Product Advisory

Issue Date: 31-March-2022

Sirius family 15x15mm substrate manufacturing process change

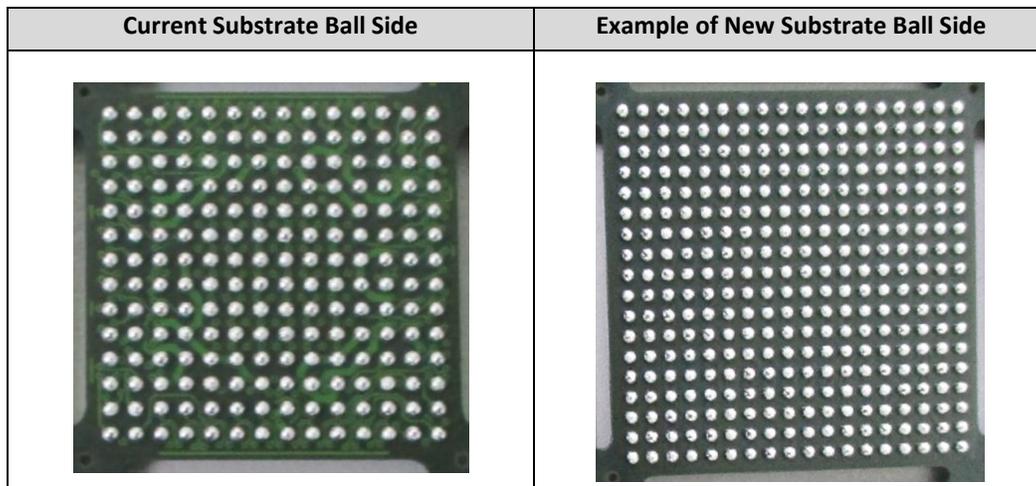
Changing substrate manufacturing process to sustain substrate supply. A visible differences on substrate ball side.

Current substrate manufacturing tooling EOL. Substrate supplier is changing to alternate substrate manufacturing process in sustaining substrate supply.

The device specification will remain the same, which will ensure product electrical performance remains the same. Appropriate electrical characterization and reliability qualification has been performed on representative products to ensure normal parametric distribution, consistent electrical performance, and reliability.
